PLANNING COMMISSION STAFF REPORT

Meeting: June 22, 2021

Consider an appeal of the Community Development Director's approval of a Two-Story Permit to allow for a new 2,922 square-foot two-story home with a 746 square-foot attached accessory dwelling unit and a Minor Residential Permit to allow for a new second-story balcony. (Application Nos.: R-2020-035, RM-2020-023; Applicant: Smart Lily, LLC.; Property Owners: Tariqul Khan and Chaman Hafiz; Appellants: Jitesh Vadhia and Chih-Lung Lin; Location: 1506 Primrose Way; APN # 366-15-018)

Figure 3. Previous front elevation

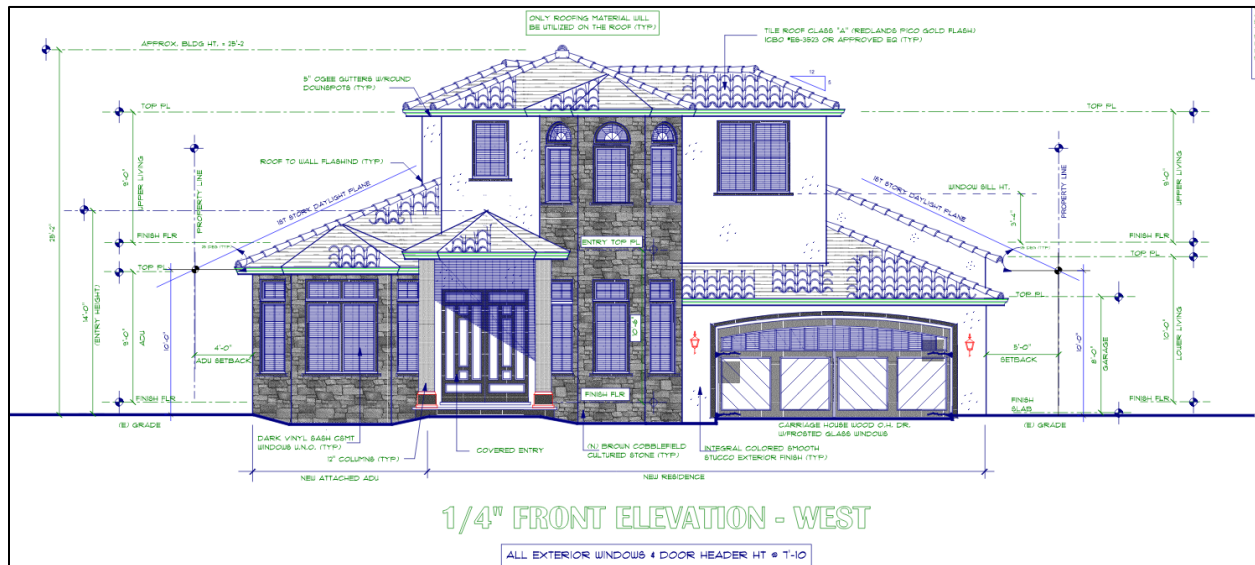
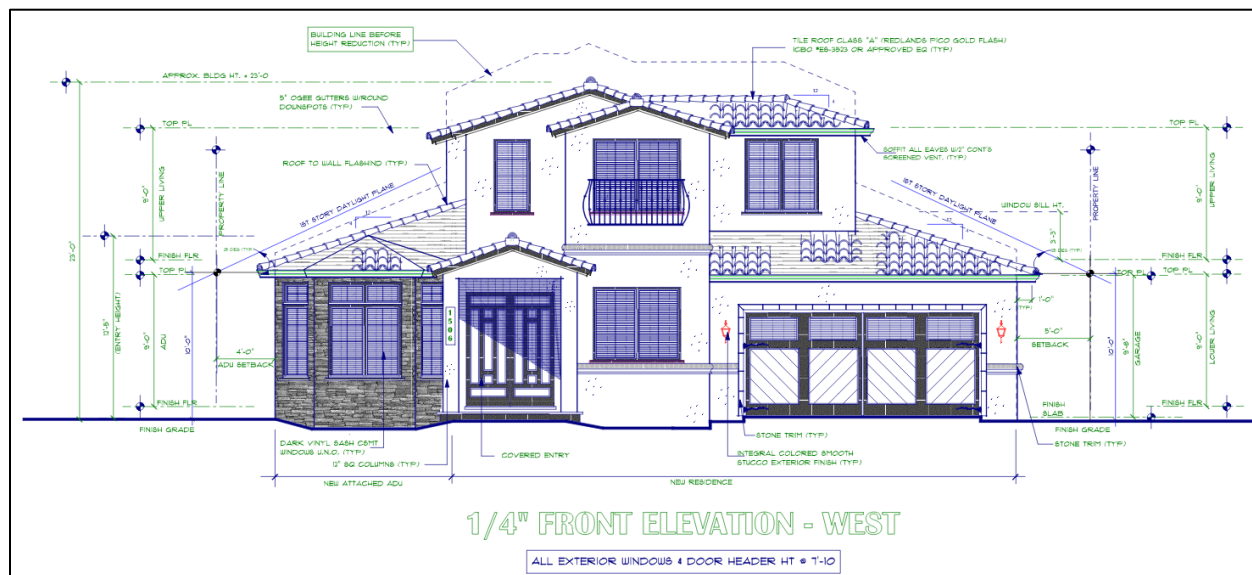
"The planning department's response on the CMC Chapter 19.28.140(A)(B)(3) says the applicant has worked with the staff to make significant design changes to be more harmonious in scale and design with the neighborhood...I can't see the significant design changes city mentioned in the revised design."

The applicant undertook design changes during the decision period to address the concerns submitted during the public comment period. Approved design changes included decreasing the overall building height, simplifying the roof lines on the first and second floor, decreasing the entry feature height, simplifying the two-story bay window feature, and making window forms more consistent throughout the design. Together, the reduced height and design changes provide better articulation of wall lines, reduce the visual mass of the exposed second story, and simplify the roofline, thus making the

project more harmonious in terms of scale and design with the surrounding neighborhood (*Figures 3 & 4*).

Figure 6. Proposed privacy plantings shown in green

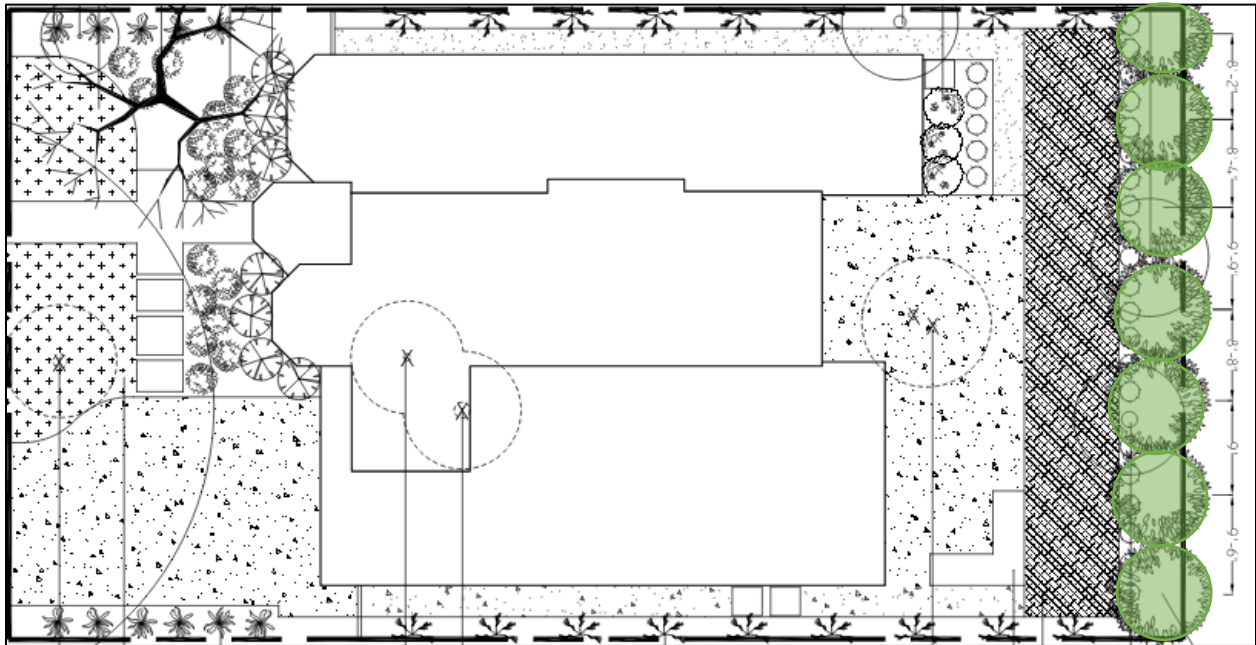
"The rear facing balcony raises severe privacy concerns. Irrespective of the privacy planting, the balcony has direct views into all my bedrooms and backyard. The height of the balcony, balcony wall height, and balcony side walls are detrimental to our privacy."

"Privacy plantings will not work. The height of the rear facing balcony requires very tall plantings. Those will take several years to grow. Additionally, power and communications cables run along the rear property lines..."

The R-1 Ordinance also allows property owners the ability to construct second-story windows and balconies as long as privacy protection trees and/or shrubs are planted and maintained as required by the ordinance. Per the R-1 Ordinance, the objective of privacy protection plantings is to provide substantial (not complete) screening within three years of planting to mitigate second-story window and balcony privacy impacts. The project complies with the privacy screening requirements of the R-1 Ordinance by providing privacy screening plantings for the second-story balcony and second-story windows with a sill height below 5-feet along the rear (eastern) property line (Figure 6). The applicant has proposed to plant seven *Laurus nobilis*, one of the City's approved privacy planting species, along the rear property line at the appropriate distance to provide adequate screening. The City's approved list of privacy plantings requires *Laurus nobilis* to be at least 15-gallon container size and have a minimum planting height of 6-feet. Privacy plantings for the right (southern) and left (northern) property lines are not required, as the applicant has obtained a signed privacy waiver form from the adjacent property owners at 1518 Primrose Way and 1492 Primrose Way.

Privacy protection plantings are considered Protected Trees under the City's Municipal Code (Chapter 14.18) and are recorded as such with a covenant against the property to inform current and future property owners about their protected status. Protected trees are not permitted to be removed without obtaining a tree removal permit and providing replacement plantings. The Code does not require privacy plantings for the first floor.
